# HISTORIC AND DESIGN REVIEW COMMISSION

August 15, 2018

**HDRC CASE NO:** 2018-328  
**ADDRESS:** 230 ADAMS ST  
**LEGAL DESCRIPTION:** NCB 943 BLK 1 LOT SW 100 FT OF 16  
**ZONING:** RM-4 CD  
**CITY COUNCIL DIST.:** 1  
**DISTRICT:** King William Historic District  
**APPLICANT:** Genevie Ramirez/Build Modern  
**OWNER:** David Roberson/Build Modern  
**TYPE OF WORK:** Exterior modifications, window replacement, porch modifications, construction of a rear addition and fencing  
**APPLICATION RECEIVED:** August 09, 2018  
**60-DAY REVIEW:**  
**REQUEST:**

230 ADAMS STREET SATX 78210

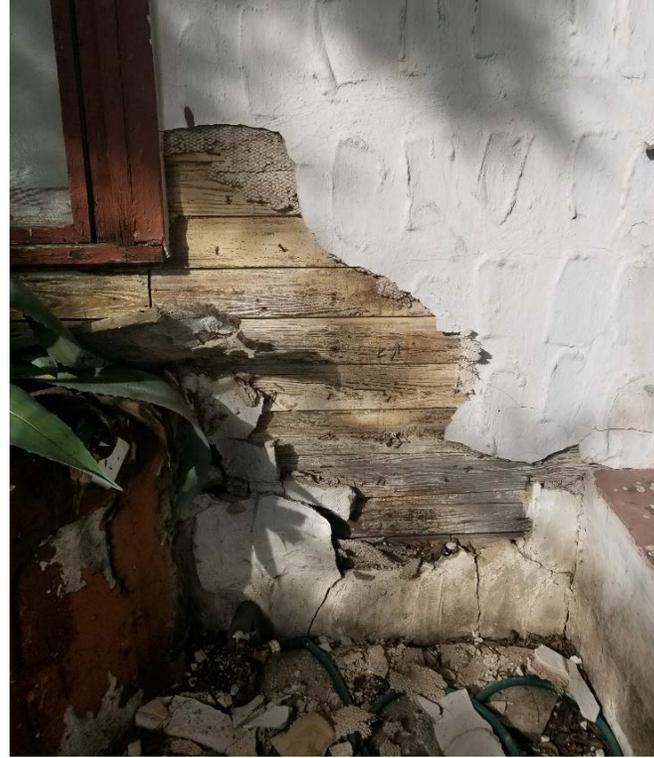
EXISTING PORCH TO REMAIN

SIDE PORCH TO REMAIN

WOOD SIDING  
EXPOSURE AT  
SECOND LEVEL

## WOOD SIDING BEHIND STUCCO/PLASTER

### PROPOSAL TO:

- REMOVE STUCCO/PLASTER
- RESTORE EXISTING WOOD SIDING OR REPLACE DAMAGED WOOD SIDING:

### REASON:

- STRUCTURE WAS NOT DESIGNED FOR STUCCO CAUSING IT TO CRACK
- STUCCO IS NOT ORIGINAL TO THE HOME
